CITY OF WESTMINSTER			
PLANNING APPLICATIONS COMMITTEE	Date 19 January 2016	Classification For General Release	
Report of Director of Planning		Ward involved West End	
Subject of Report	27 and 28 Curzon Street and 18 Market Mews, London W1J 7TJ		
Proposal	Erection of new and replacement rear second floor structures to enclose enlarged terrace for use in association with casino (<i>Sui Generis</i>), installation of replacement plant at main roof level, installation of replacement canopy at front ground floor level and removal of timber screens from roof level. Internal alterations.		
Agent	Daniel Rinsler & Co.		
On behalf of	Crown Aspinalls		
Registered Number	15/07744/FULL and 15/07745/LBC	Date amended/ completed	21 August 2015
Date Application Received	20 August 2015		
Historic Building Grade	Grade II (No. 28 Curzon Street)		
Conservation Area	Mayfair

DRAFT DECISION LETTER (15/07744/FULL)

Proposed second floor plan.

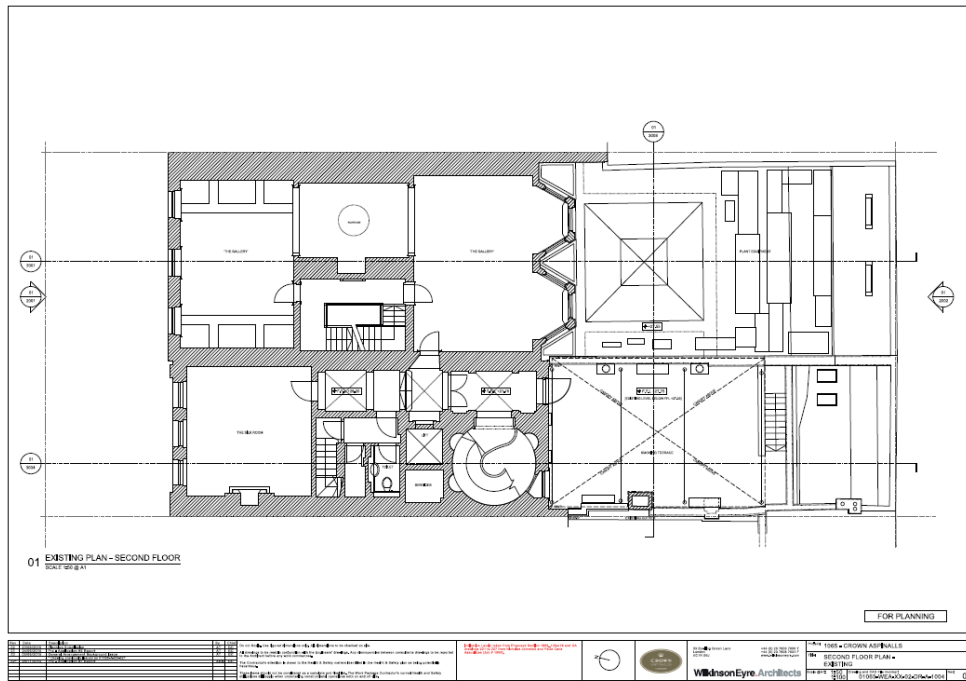
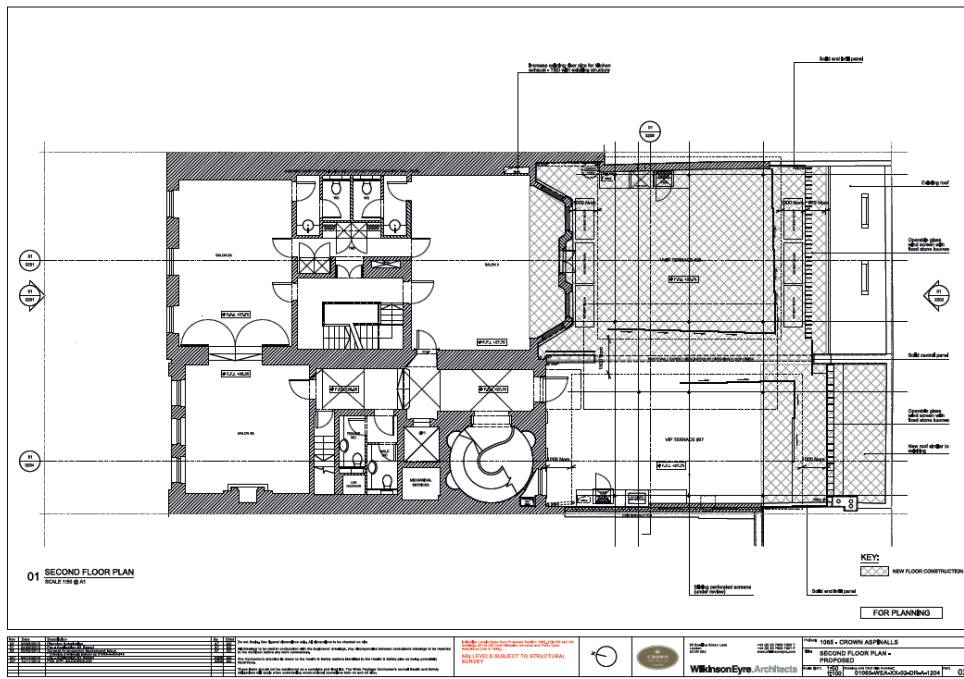
In terms of overlooking, a combination of the nature of the proposed use and the wind screens with vertical slate louvres that will mitigate any overlooking, it is considered that the two terraces will not cause a material increase in overlooking to the residential properties on the south side of Market Mews.

The main changes are at the rear of the buildings, above the mews buildings. Here a smoking enclosure on No. 27 is replaced with a new flat roofed, semi- open structure, which extends onto No. 28, replacing unsightly plant. The structure is set back from the mews to reduce its visibility, and its main impact is on the view from the junction of Market Mews and Pitt's Head Mews. It is also visible obliquely from the east from Market Mews. The use of the slate fins seeks to give it a neutral, roof-like appearance. At the main roof level there is a large amount of plant, which appears to be unauthorised. This will be replaced and rationalised to reduce its visual impact. This is beneficial.

- 7 The glass wind screen with fixed slate louvres hereby approved at rear second floor level shall be installed in full and retained in situ for as long as rear second floor terraces are in

- 11 You must apply to us for approval of detailed drawings of the alterations to the Curzon Street entrances, including the following alteration to the scheme.

Only one canopy shall be provided at the front (Curzon Street) entrance (either 27 or 28), and not one on each building.
